James Scarola
Vice President
Harris Nuclear Plant

SHEARON HARRIS NUCLEAR POWER PLANT
DOCKET NO. 50-400/LICENSE NO. NPF-63
STEAM GENERATOR REPLACEMENT
LICENSE AMENDMENT REQUEST
ERRATA SHEETS

ERRATA SHEETS FOR ENCLOSURE 6 TO HNP-00-142, DATED OCTOBER 4, 2000

ERRATA SHEETS FOR WCAP-15399 (Non-proprietary)

Figure 6.1.3-1 Post-LOCA Sump Boron Concentration

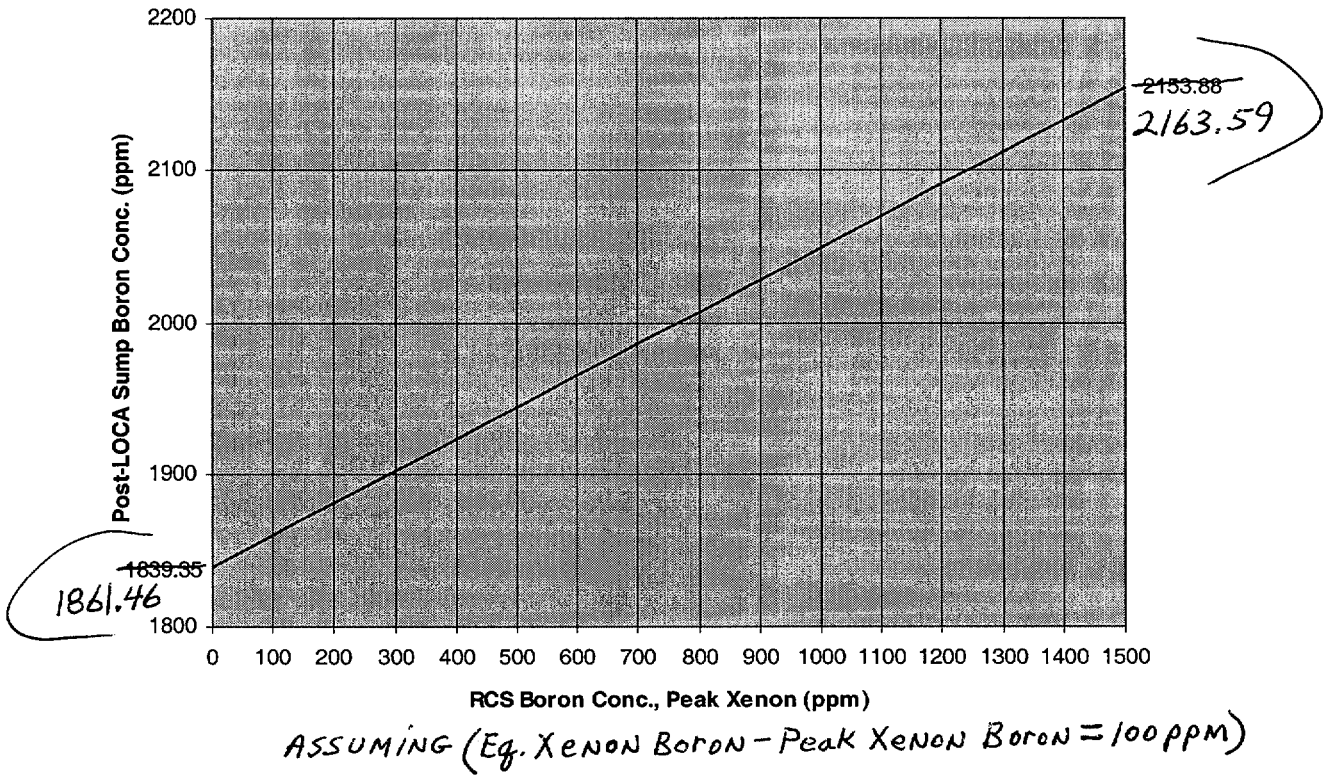
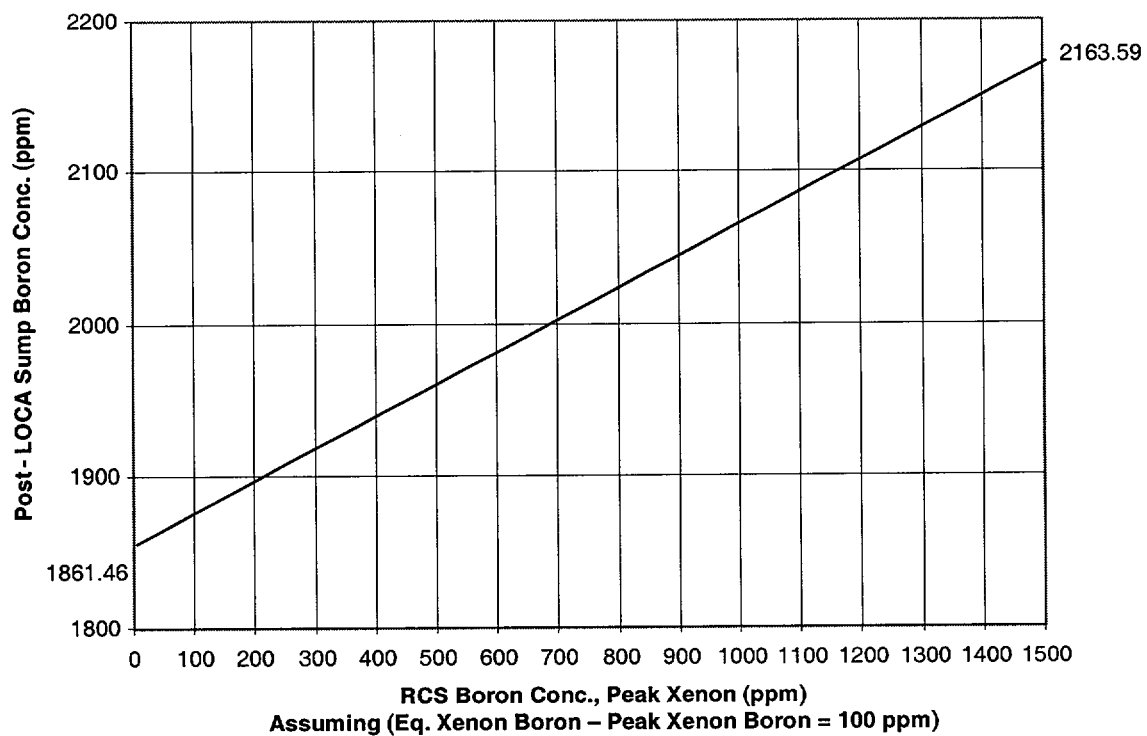
Mixed Mean Sump Boron Calculation: The results were tabulated for RCS boron concentration of 0 and 1500 ppm assuming the pre-trip RCS boron concentration for peak xenon concentration to be 100 ppm lower than the equilibrium xenon case. The straight-line curve (See Figure 6.1.3-1.) fit for the two points provided above is:

$$\begin{matrix} \rightarrow & & 0.20142 \\ & & y = 0.20969x + 1839.35 \\ & & \quad \quad \quad 1861.46 \end{matrix}$$

$$\begin{matrix} \rightarrow & & 0.20142 & 0.03653 & 1857.81 \\ & & y = 0.20969x + 0.038036n + 1835.542 \end{matrix}$$

$$y = 0.20142 x + 1861.46$$

$$y = 0.20142 x + 0.03653 n + 1857.81$$

Figure 6.1.3-1 Post-LOCA Sump Boron Concentration

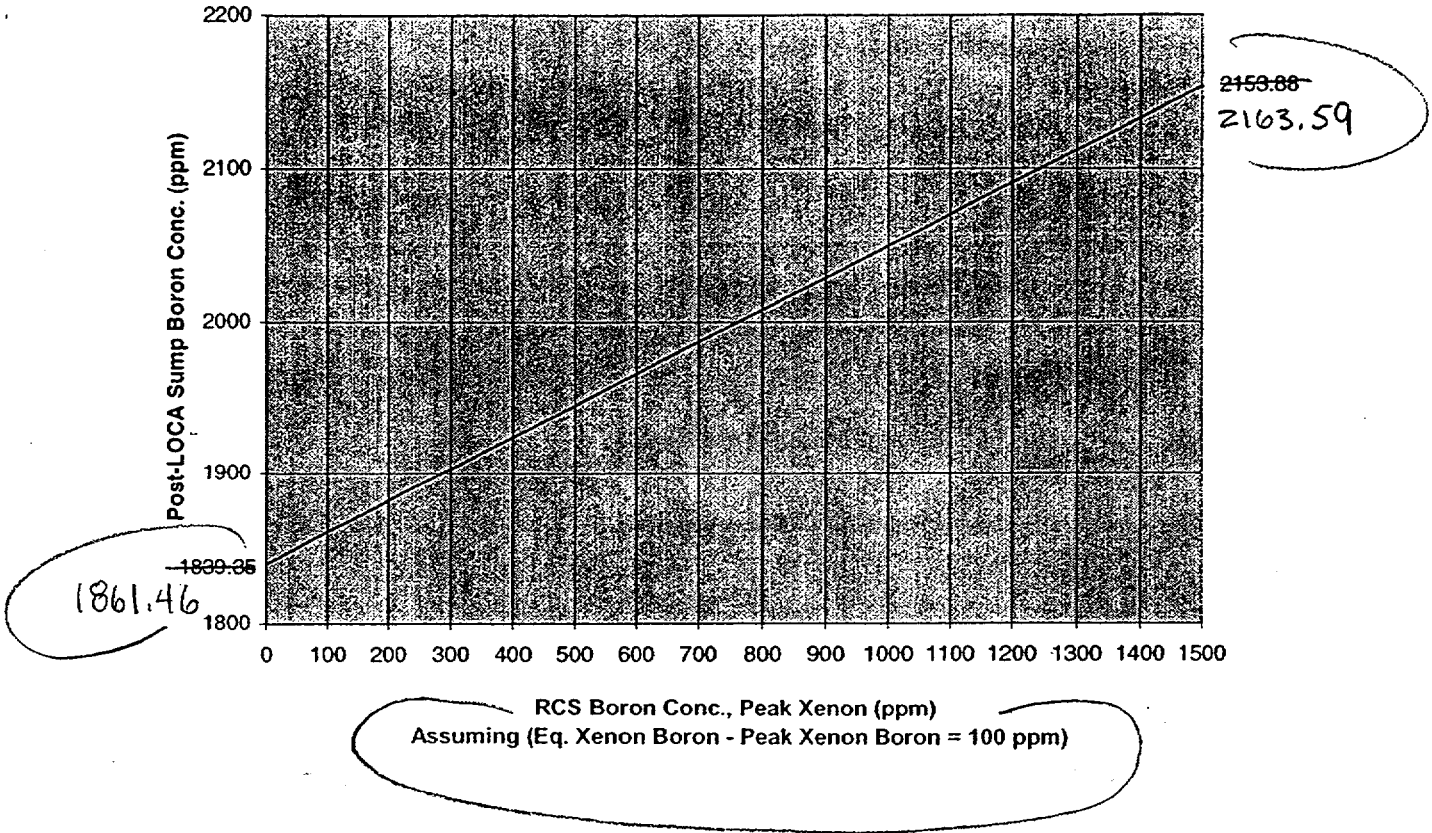
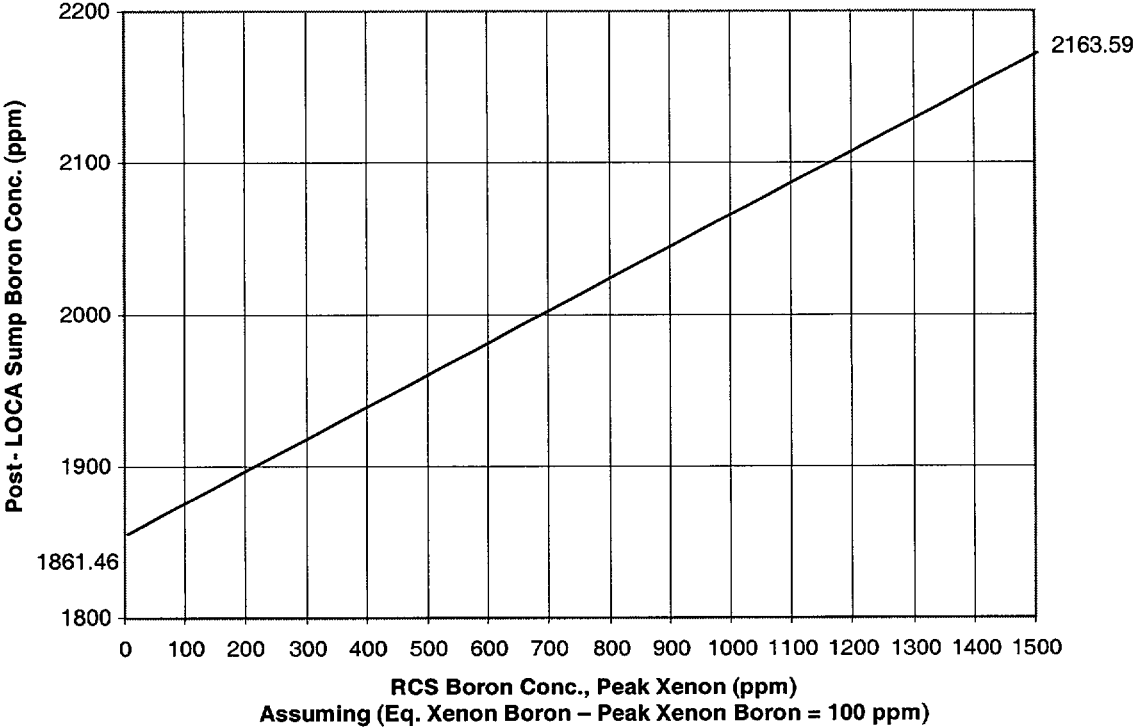
$$y = 0.20969 x + 1839.35$$

An alternate equation is provided below where "n" is the difference in boron concentration between the peak and equilibrium xenon concentration case. (See Figure 6.1.3-1.)

$$y = 0.20969 x + 0.038036 n + 1835.542$$

$$y = 0.20142 x + 1861.46$$

$$y = 0.20142 x + 0.03653 n + 1857.81$$
